Serial No.: 09/859,706

Art Unit: 3673

**Amendments to the Drawings**

**REMARKS**

*Fig. 3*

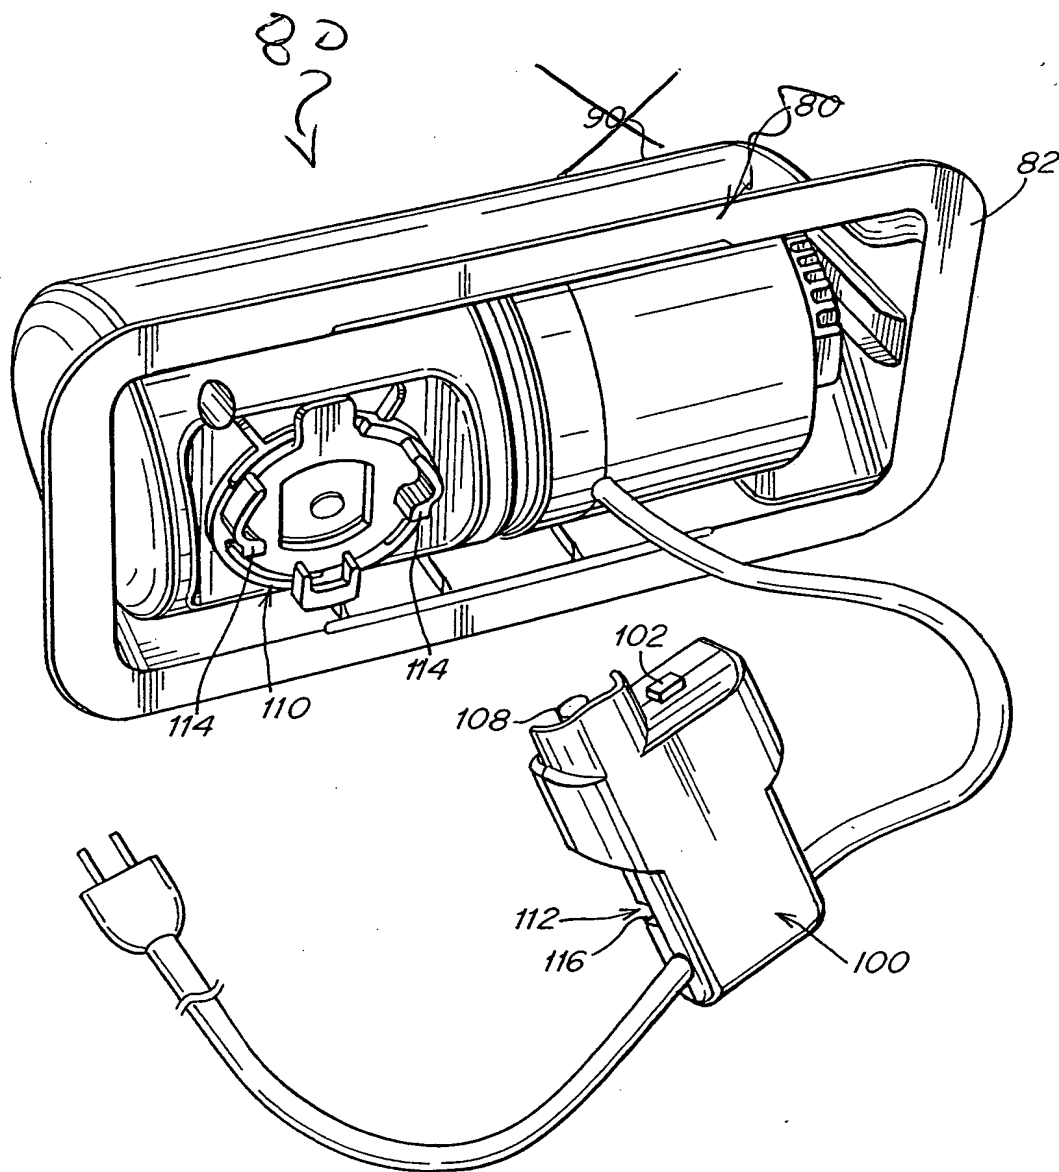
The Office Action objects to the drawings as failing to comply with 37 CFR 1.84 (p)(4) because reference character “90” has been used to indicate both the housing “90” connected to the flange “82” as shown in FIG. 3 and the housing or covering around the motor (84), impeller (86), conduit (88), solenoid (104), etc. as shown in FIG. 5. Applicant has deleted reference character 90 from FIGS. 3 and 4 of the enclosed annotated drawings so as to eliminate any confusion. It is clear from the specification that the reference character 90 refers to the housing 90 that surrounds the inner workings of the pump 81, such as the motor (84), impeller (86), conduit (88), solenoid (104), etc., and can also serve as a connection between the fluid controller 80 and the bladder 20. Accordingly, withdrawal of this objection is respectfully requested.

As to claims 5, 6, 8, 9, and 26, the Office Action asserts that they all recite a "housing" which is confusing because the specification and drawings are not clear as to what constitutes the housing (i.e., is it the structure connected to the flange (82) as shown in FIG. 3 or is it the structure surrounding the motor (84), impeller (86), conduit (88), solenoid (104), etc. as shown in FIG. 5?). As has been discussed above, the housing 90 surrounds, for example, the motor, the impeller, the conduit, the solenoid, etc. as shown in FIG. 5 and any reference to the housing 90 in FIGS. 3 and 4 have been deleted. Thus, the drawings have been corrected and the claims are

The Office Action also objected to the drawings asserting that the reference numerals “83” and “90” have both been used to designate “fluid impermeable wall” (see FIG. 5) and “housing” (see FIG. 3). As noted above, FIGS. 3 and 4 have been amended to eliminate to reference character “90” from these figures, as the fluid impermeable wall is designated by the reference number 83 in FIG. 5. Accordingly, the drawings have been corrected and withdrawal of this objection is respectfully requested.
